28 PERFORATOR-TRANSMITTER-BASE REQUIREMENTS AND ADJUSTMENTS

1.001 This addendum supplements Section P34.660, Issue 2.

1.002 This addendum is issued to revise requirements on the manual and power-drive backspace mechanisms, to add requirements for auxiliary contacts, letters and figures contacts, and transmitting code-reading contacts, and to add reference to another associated Bell System Practice.

2.17.1 Auxiliary Contacts

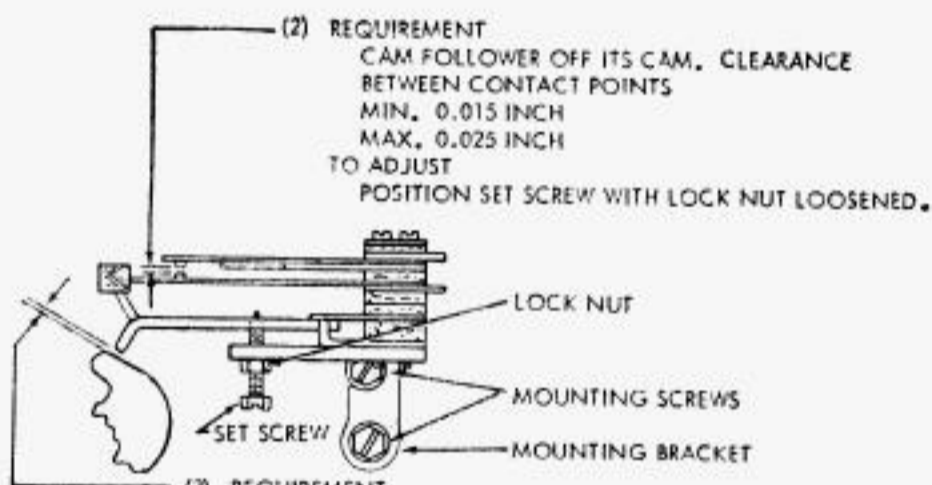
(1) REQUIREMENT
 CAM FOLLOWER ON HIGH PART OF CAM
 MIN. 3-1/2 OZS.
 MAX. 4-1/2 OZS.
 TO SEPARATE THE CONTACTS.
 TO ADJUST
 BEND UPPER CONTACT SPRING.

(2) REQUIREMENT
 CAM FOLLOWER OFF ITS CAM. CLEARANCE
 BETWEEN CONTACT POINTS
 MIN. 0.015 INCH
 MAX. 0.025 INCH
 TO ADJUST
 POSITION SET SCREW WITH LOCK NUT LOOSENED.

(3) REQUIREMENT
 CLUTCH DISENGAGED. CLEARANCE BETWEEN CAM
 FOLLOWER AND CAM
 MIN. SOME
 MAX. 0.005
 TO ADJUST
 POSITION MOUNTING BRACKET WITH ITS MOUNTING
 SCREWS LOOSENED. THIS ADJUSTMENT IS TO BE REFINED
 WHEN STROBING IS DONE.

NOTE
 THERE SHOULD BE AT LEAST 0.010 CLEARANCE BETWEEN
 THE CONTACT GUARD AND THE TRANSFER BAIL; AND
 THERE SHOULD BE AT LEAST 0.015 INCH CLEARANCE
 BETWEEN THE LOWER EXTENSION OF THE CAM FOLLOWER
 ARM AND THE INSIDE SURFACE OF THE CLUTCH DISK.
 IF NECESSARY, LOOSEN THE TWO CONTACT ASSEMBLY
 MOUNTING SCREWS AND POSITION THE CONTACT
 ASSEMBLY AND THE CAM FOLLOWER HINGE.

2.66 Backspace Mechanism (Manual and Power Drive)

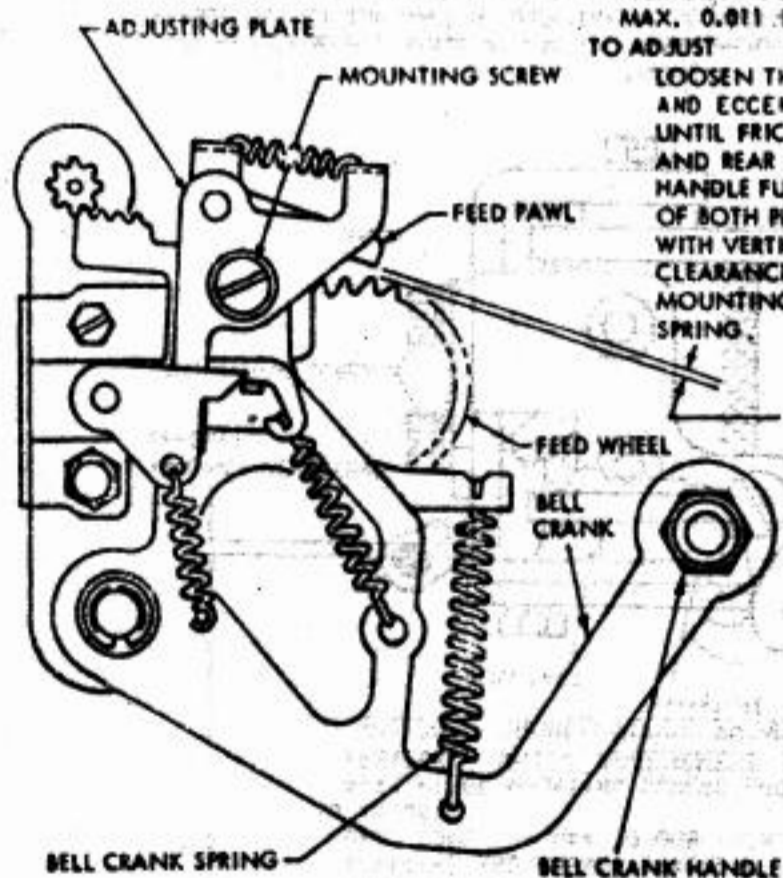
(1) REQUIREMENT

WITH ROTATIONAL PLAY IN RAKE TAKEN UP TO LEFT, BOTTOM SURFACE OF RAKE TEETH SHOULD BE IN SAME VERTICAL PLANE AS LEFT SIDE OF PUNCH BLOCK OR SLIGHTLY TO THE RIGHT.

TO ADJUST

REMOVE TWO MOUNTING SCREWS FROM REAR PLATE. POSITION RAKE SHAFT GEAR IN RELATION TO GEAR SEGMENT. REPLACE MOUNTING SCREWS.

(2) REQUIREMENT

WITH BELLCRANK SPRING UNHOOKED AND RAKE IN OPERATED POSITION, CLEARANCE BETWEEN BOTTOM OF RAKE TEETH AND LOWER SURFACE OF TAPE SLOT: MIN. 0.007 INCH MAX. 0.011 INCH (CHECK AT NO. 1 & 5 PINS.)

TO ADJUST

LOOSEN THREE MOUNTING SCREWS AND ECCENTRIC MOUNTING SCREW UNTIL FRICTION TIGHT. POSITION FRONT AND REAR PLATES, WITH BELL CRANK HANDLE FULLY DEPRESSED, UNTIL LEFT EDGES OF BOTH PLATES ARE APPROXIMATELY IN LINE WITH VERTICAL PLANE OF PUNCH BLOCK AND CLEARANCE MEETS THE REQUIREMENT. TIGHTEN MOUNTING SCREWS AND REPLACE BELL CRANK SPRING.

FEED PAWL ADJUSTING PLATE REQUIREMENT

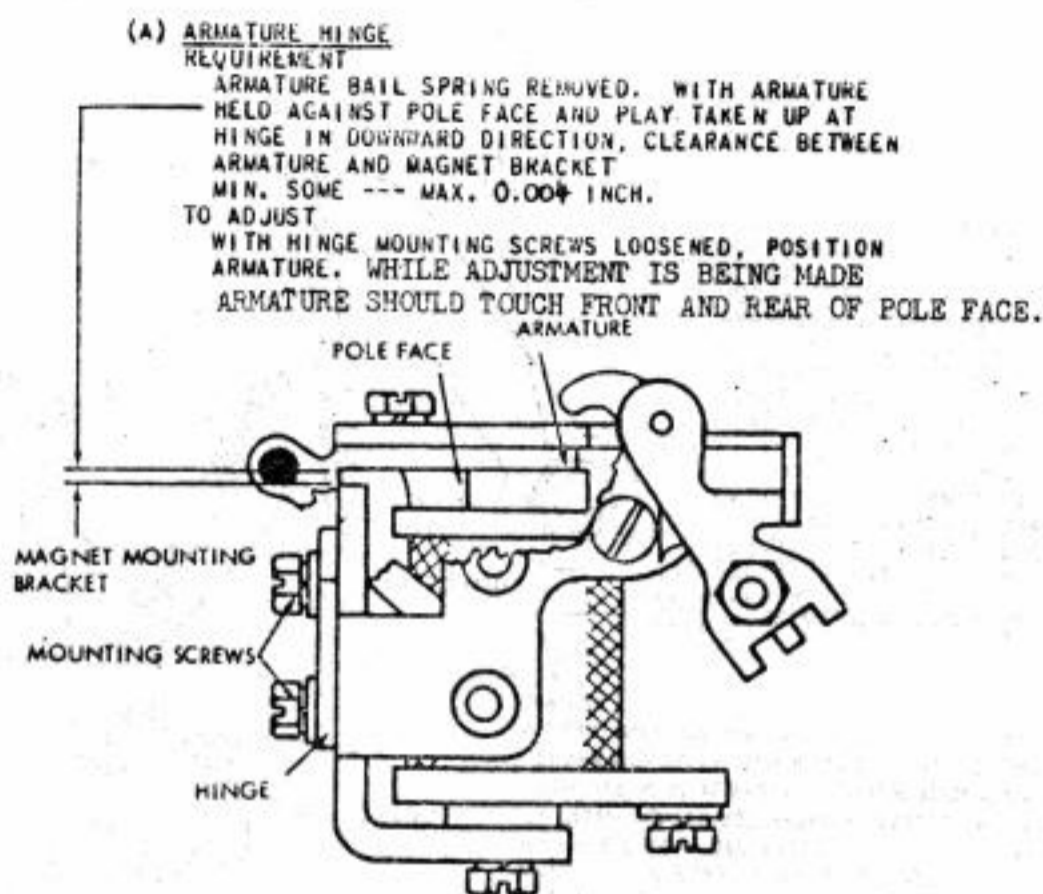
- (1) PRELIMINARY: WITH BELL CRANK ROTATED CLOCKWISE, FEED PAWL SHALL MISS FIRST TOOTH AT POINT OF LEAST CLEARANCE BY MIN. 0.008 INCH - MAX. 0.040 INCH
- (2) FINAL: FEED PAWL SHALL MISS FIRST TOOTH AND ENGAGE SECOND TOOTH BY AT LEAST 1/2 OF RIGHT ENGAGING SURFACE OF FEED PAWL (AS GAUGED BY EYE WHEN FEED PAWL FIRST CONTACTS RATCHET TOOTH).

TO ADJUST

POSITION ADJUSTING PLATE WITH MOUNTING SCREW FRICTION TIGHT.

2.68 Backspace Mechanism (Power Drive)

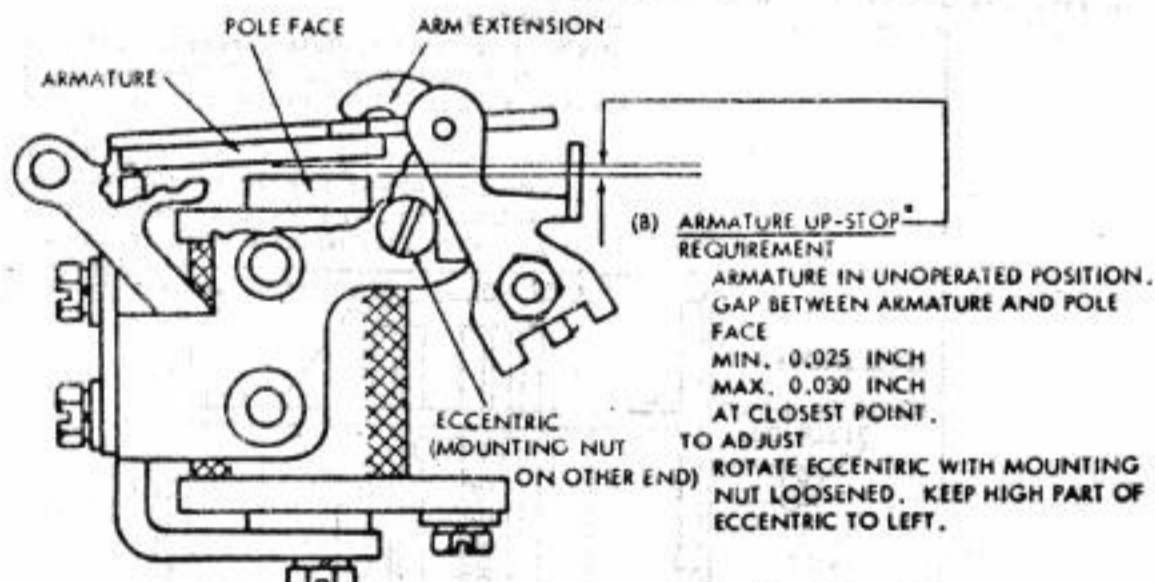
*NOTE:
THIS ADJUSTMENT IS MADE AT FACTORY AND SHOULD NOT BE DISTURBED UNLESS A REASSEMBLY OF THE UNIT IS UNDERTAKEN. IF NECESSARY TO MAKE THIS ADJUSTMENT, THE PUNCH UNIT SHOULD BE REMOVED. SEE DISASSEMBLY AND REASSEMBLY. REMAKE PUNCH UNIT POSITION ADJUSTMENT.
